ADDENDUM

PROJECT	Black Hawk County Courthouse Renovations	PROJECT #	23109
OWNER	Black Hawk County	DATE	January 19, 2024
LETTING DATE	January 29, 2024	ADDENDUM #	1

4 MEPT – see attachment with MODUS titleblock noted "Addendum #1".

BLACK HAWK COUNTY
COURTHOUSE RENOVATIONS
316 E 5th Street, Waterloo, IA 50703PROJECT NO:
23109DATE:
JANUARY 4, 2024
SHEET SET:
BID DOCUMENTSSHEET NAME:
BASEMENT ELECTRICAL
DEMOLITION PLANSHEET:
ED1.01
Copyright © 2022

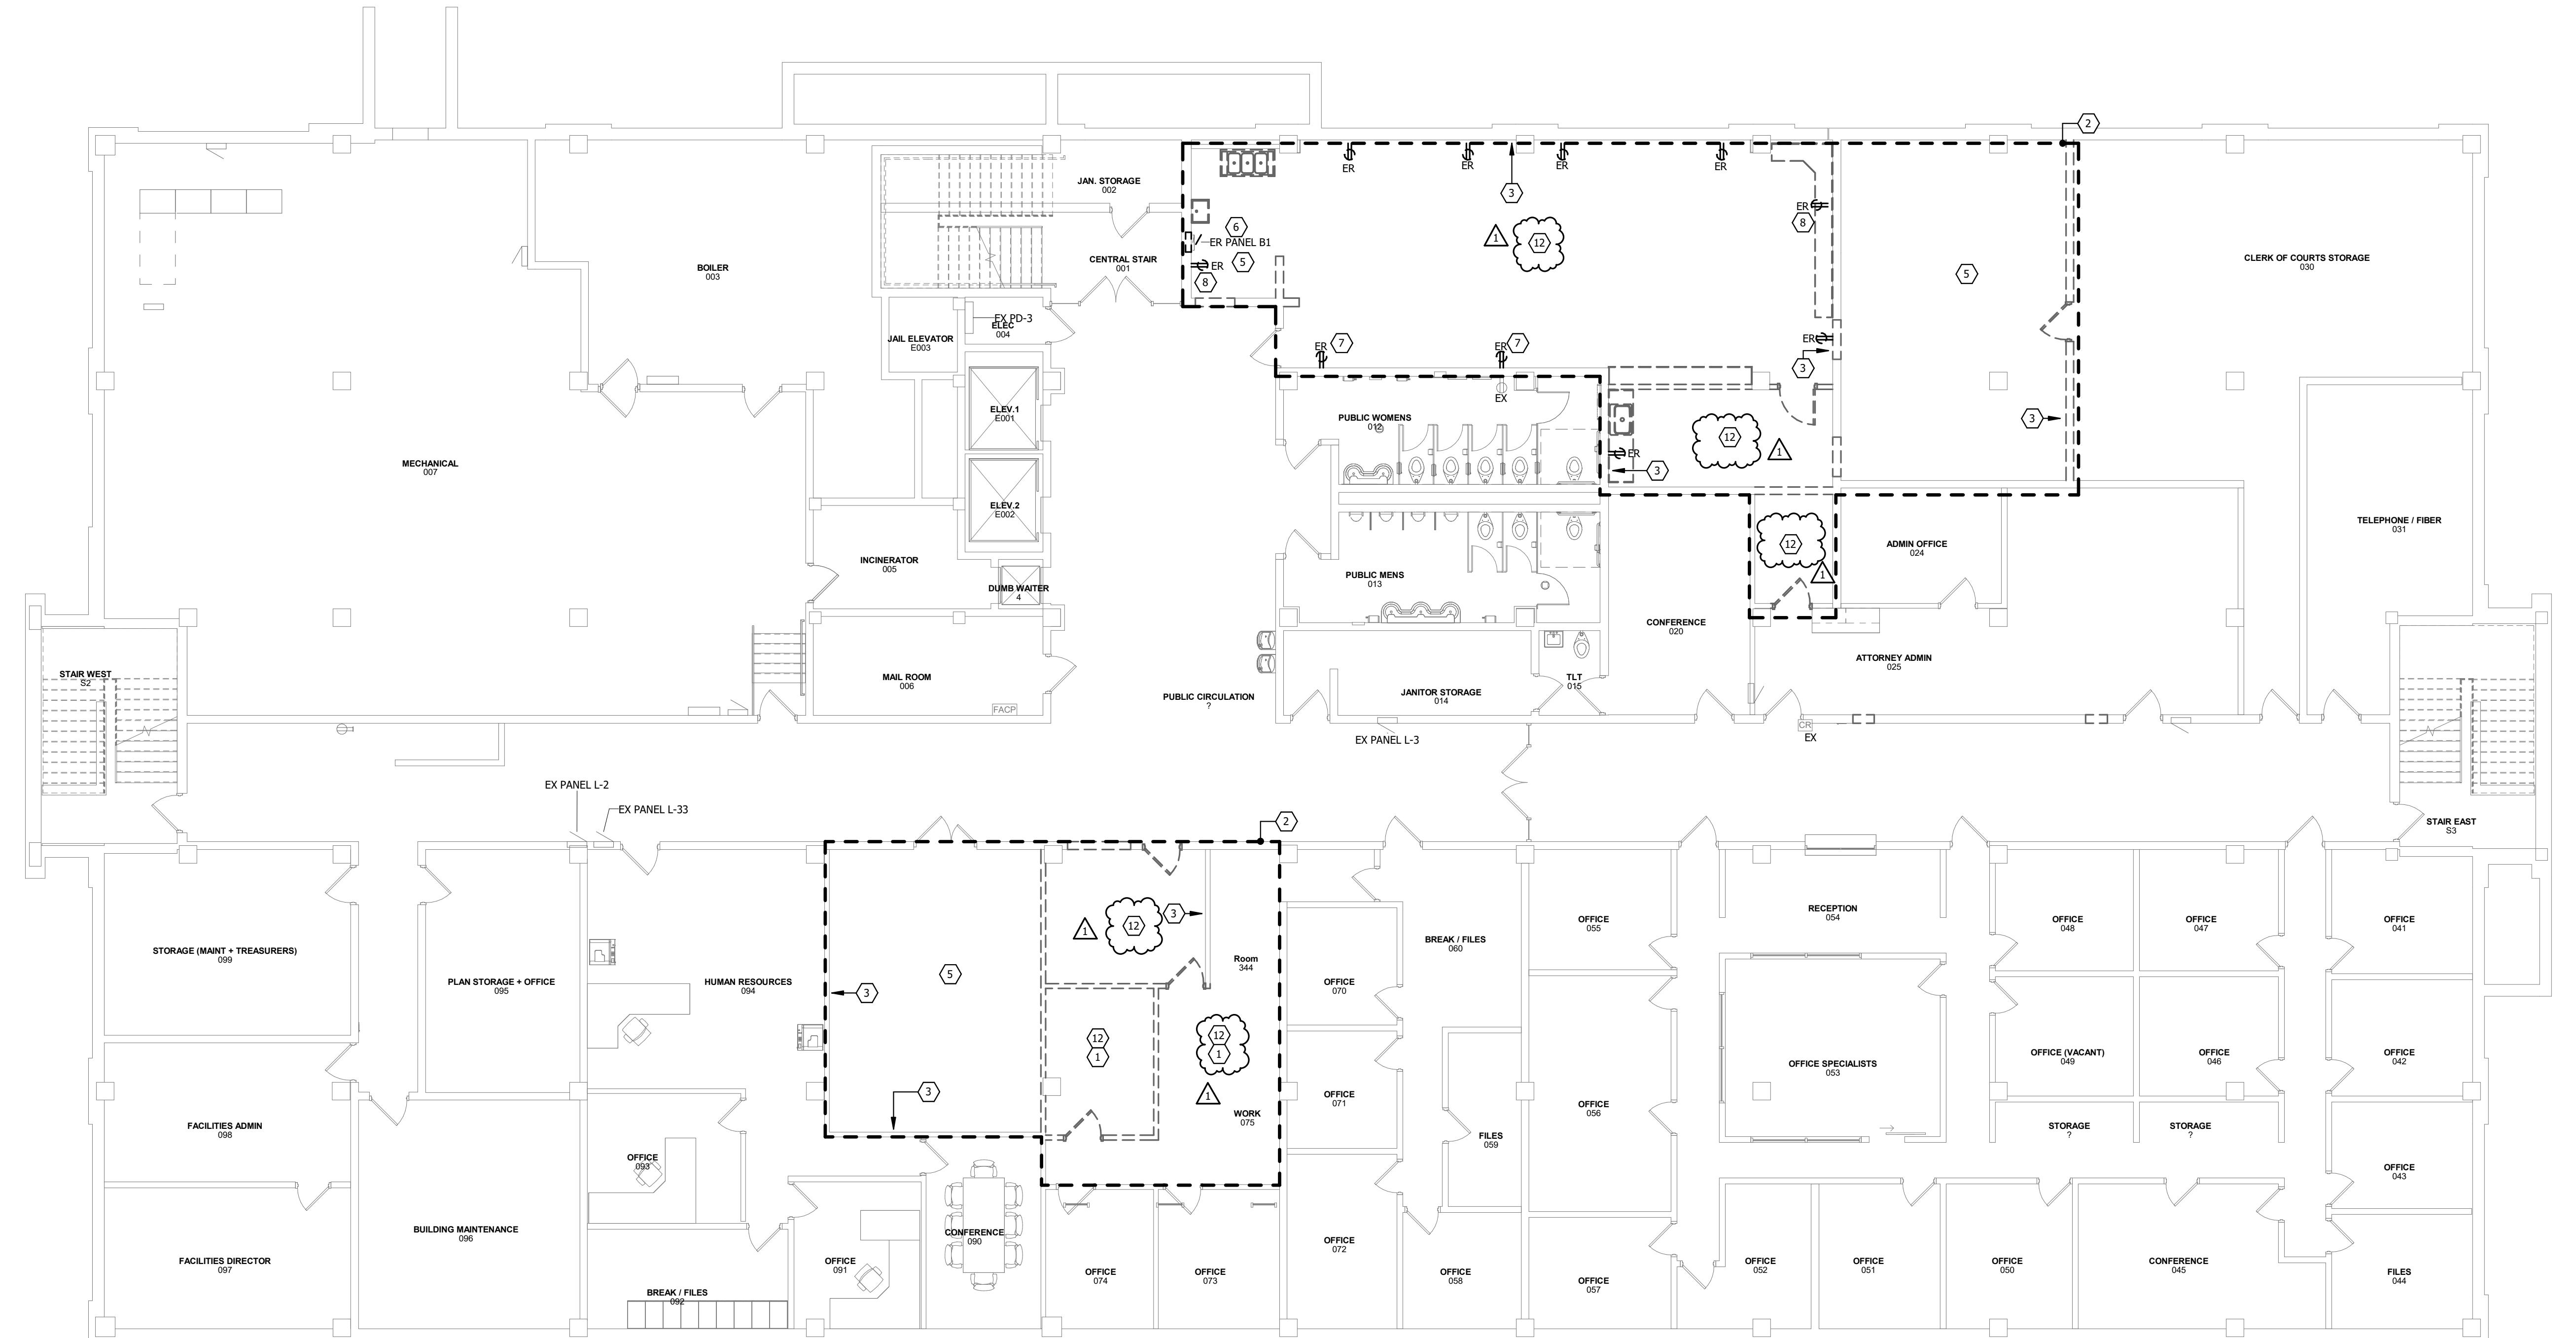
SHEET ED I .O I BASEMENT ELECTRICAL DEMOLITION PLAN

1. **REVISE.** Existing 2x2 and 2x4 lighting that meets the owner's standard Lithonia troffers are to be salvaged and reused. Refer to reissued sheets for more information and revised referenced notes.

SHEET ED 1.1 | FIRST FLOOR ELECTRICAL DEMOLITION PLAN

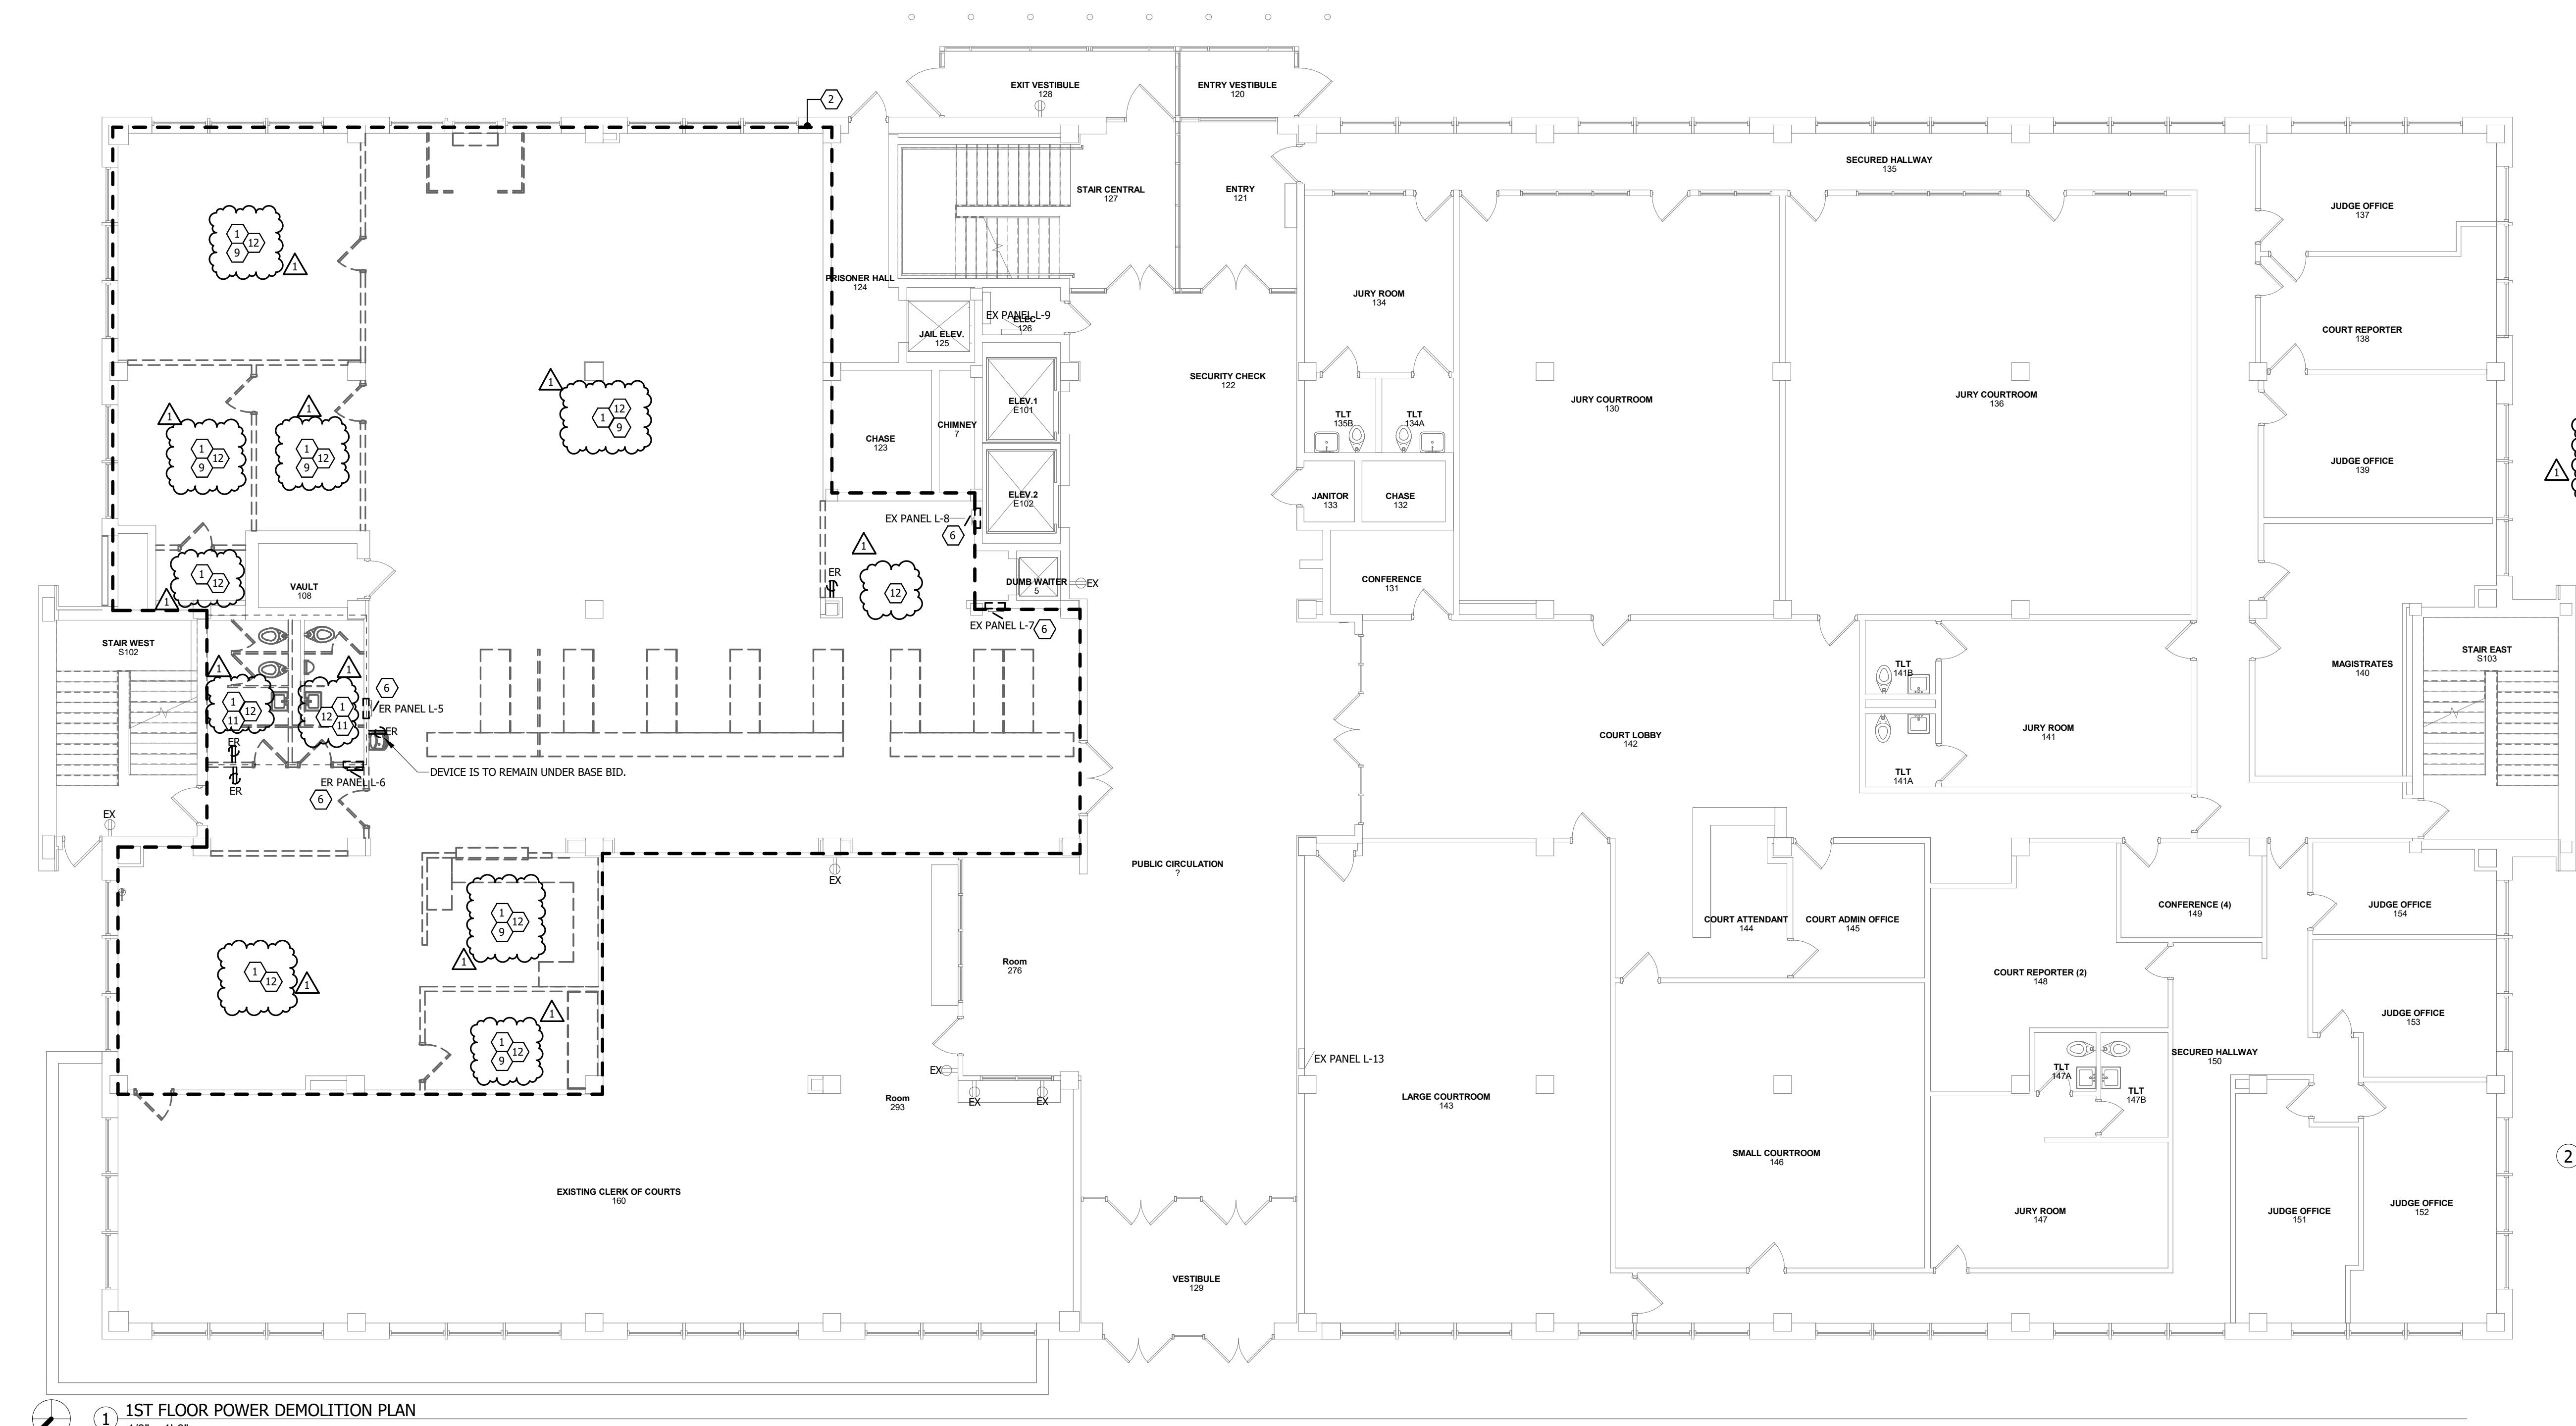
1. **REVISE.** Existing 2x2 and 2x4 lighting that meets the owner's standard Lithonia troffers are to be salvaged and reused. Refer to reissued sheets for more information and revised referenced notes.
2. **REVISE** outlet shown on column near panel L-8 shall to be tagged ER in lieu of EX.

SHEET NAME:
**SECOND FLOOR
ELECTRICAL
DEMOLITION PLAN**

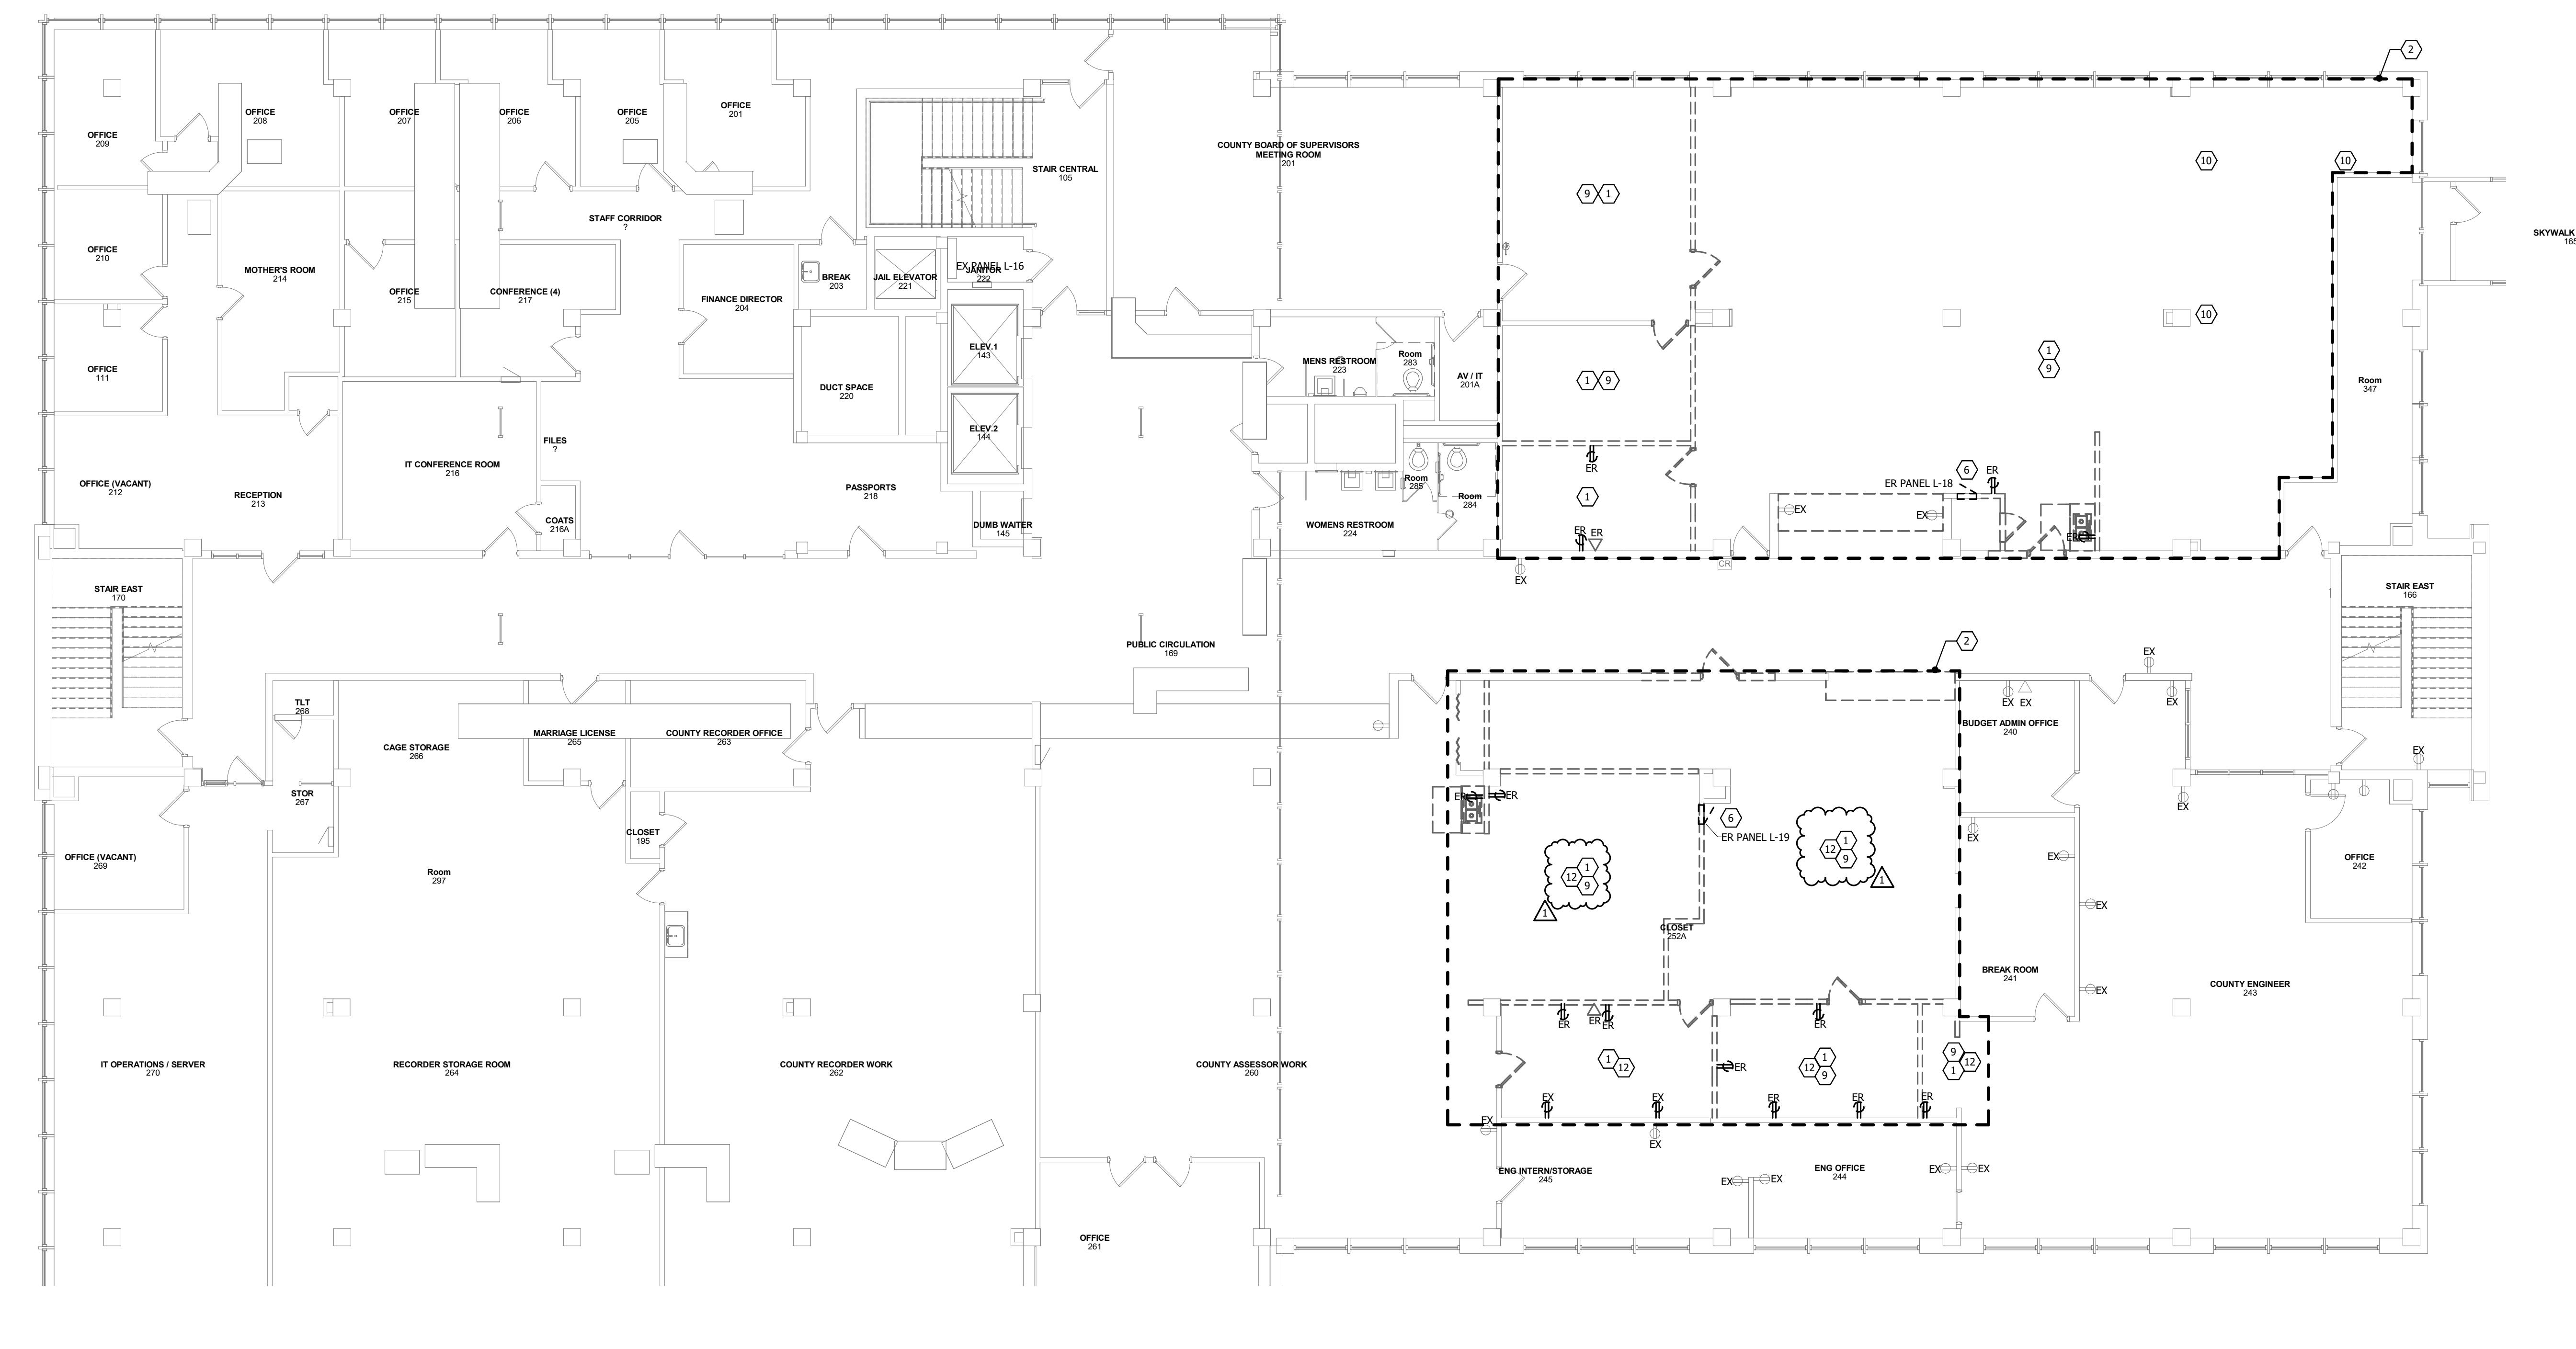
SHEET ED 1.2 | SECOND FLOOR ELECTRICAL DEMOLITION PLAN

1. **REVISE.** Existing 2x2 and 2x4 lighting that meets the owner's standard Lithonia troffers are to be salvaged and reused. Refer to reissued sheets for more information and revised referenced notes.
